Service Bulletin

Product Line: Snowmobile

Bulletin No: 2003-1-13

Subject: Speedometer Cable Routing

Fig. 1

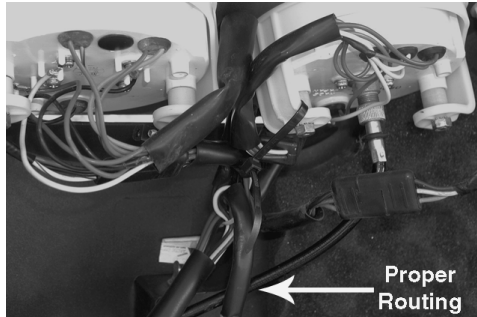
Condition: It has been determined that the speedometer cable on the affected models may come into contact with the top of the air silencer plenum causing possible damage to the cable.

Solution: Disconnect the speedometer cable; then reroute the cable behind the hood harness making sure the cable slack is pulled toward the gauge. Connect the speedometer cable. See Fig. 1 for proper routing.

Fig. 2

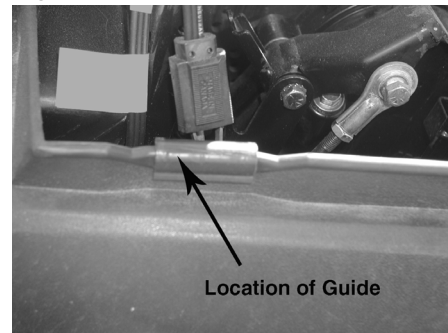
■ **NOTE:** Installing the belly pan guides will raise the hood slightly, allowing more clearance between the speedometer cable and the top of the air silencer plenum.

Also install Belly Pan Guide (p/n 0619-611) on each side of the belly pan near the rear of the belly pan. See Fig. 2 for the proper location of the guide.
